THI QAR VILLAGE ROADS  
SEGMENT 3  
GOVERNORATE OF  
THI QAR, IRAQ

**SIGIR-PA-06-059**  
**OCTOBER 26, 2006**

SUBJECT: Report on Project Assessment of Thi-Qar Village Roads Segment 3 Project,  
Thi-Qar, Iraq (Report Number SIGIR-PA-06-059)

**Figure 1: Thi Qar Village Roads Segment 3 Project**

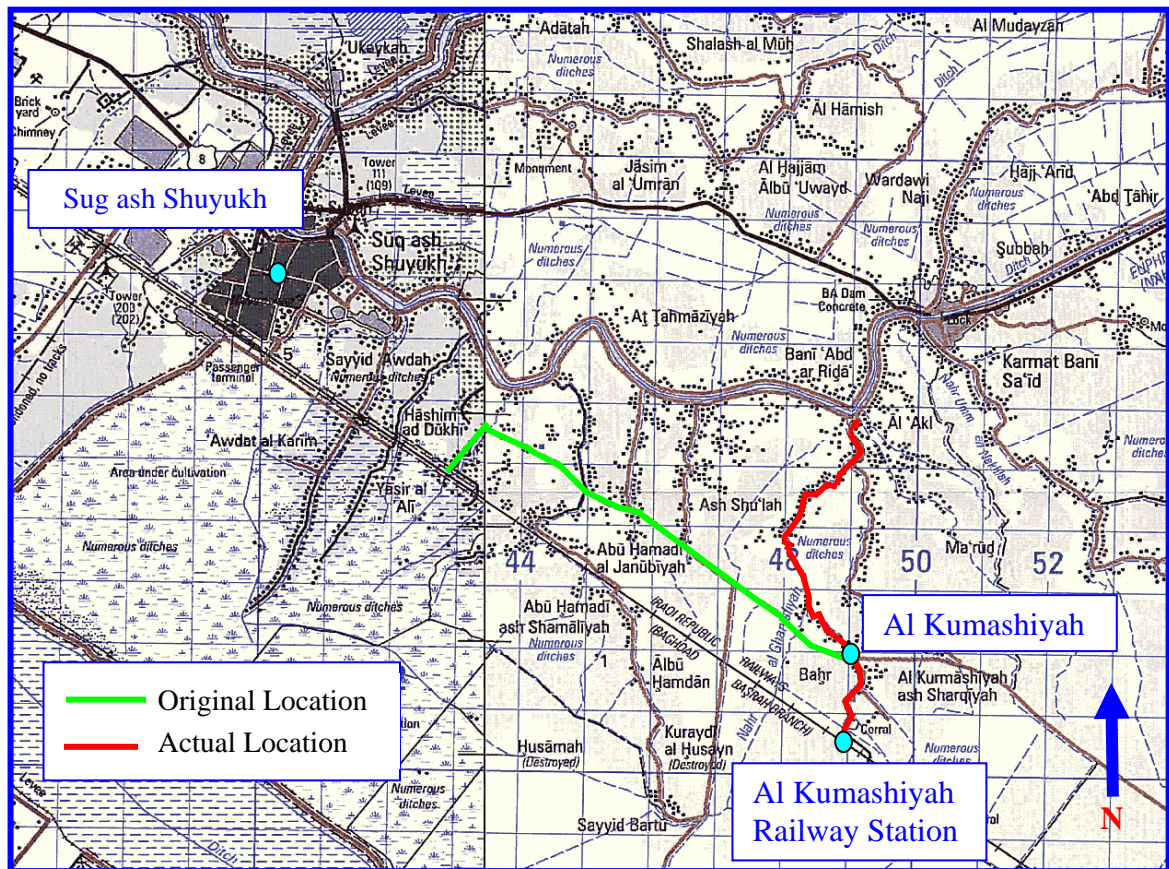
The project objective was to construct a 7.1 kilometer (km) paved village road in the Governorate of Thi Qar for everyday use by the local population. At the time of our assessment, the contract showed a location for the road alignment as depicted in green on Figure 1. However, based on discussions with the USACE Project

Engineer (PE)<sup>1</sup> working in the USACE’s Thi Qar Resident Office, responsible for managing the project, the location of the project changed after the contract award at the request of the Director General (DG) for the Iraq State Commission of Roads and Bridges (SCRB). The DG in a letter to the USACE stated:

*“After being awarded by the USACE to [a local Iraqi company], we received a map from the USACE designates the location of the road. After checking the location of the road on the map of the USACE, we found out that the road is not right and it is not the same road that we surveyed and there was a mistake in the map. We informed the GRS that the marked road is in the wrong location and we informed the project engineer to correct that mistake and the USACE agreed on that as we informed them with the right grid coordinates.”*

The grid coordinates provided by the SCRB delineated the alignment shown in red in Figure 1. The new alignment parallels an irrigation canal and runs in a north-south direction. The northern terminus of the road is at the Euphrates River. The road ends in the south at the Al Kumashiyah Railway Station.

**Figure 2. Typical fill cross section**

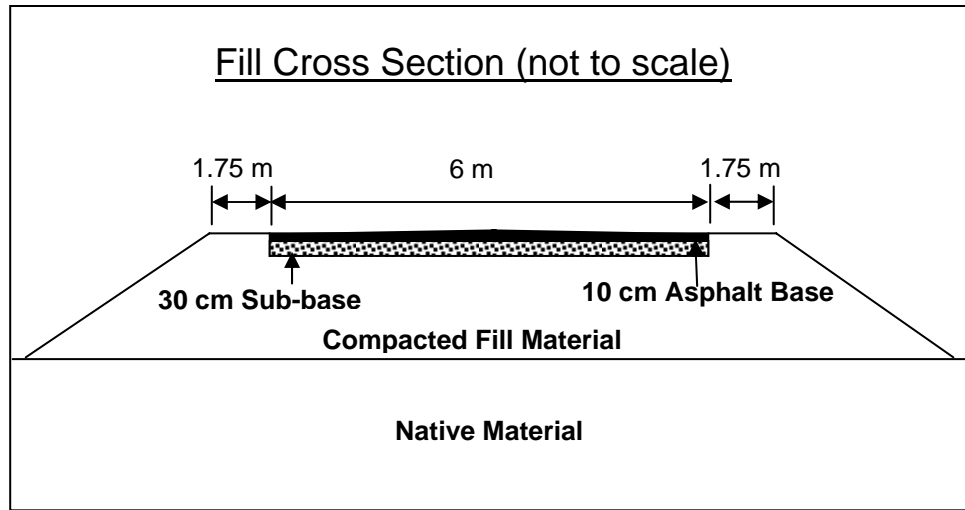
For an illustration of the typical fill cross section provided in the contract drawings, see Figure 2.

The BOQ required the contractor to place 95,000 m<sup>3</sup> of fill material. Although, we were not able to verify quantities, we reviewed USACE Quality Assurance (QA) reports to determine the adequacy of the earthwork in constructing the fill sections along the 7.1 km roadway. Based on our review, the earthwork construction appeared to meet the requirements of the contract. The material stockpiled along the roadway prior to placement appeared capable of being compacted to form a stable fill area with side slopes as shown in Figure 2. Site Photos 1 and 2 show the material stockpiles used to construct fill sections. Site Photo 1 shows a dump truck placing material along the roadway. In Site Photo 2 a motor grader is leveling the material prior to compaction.
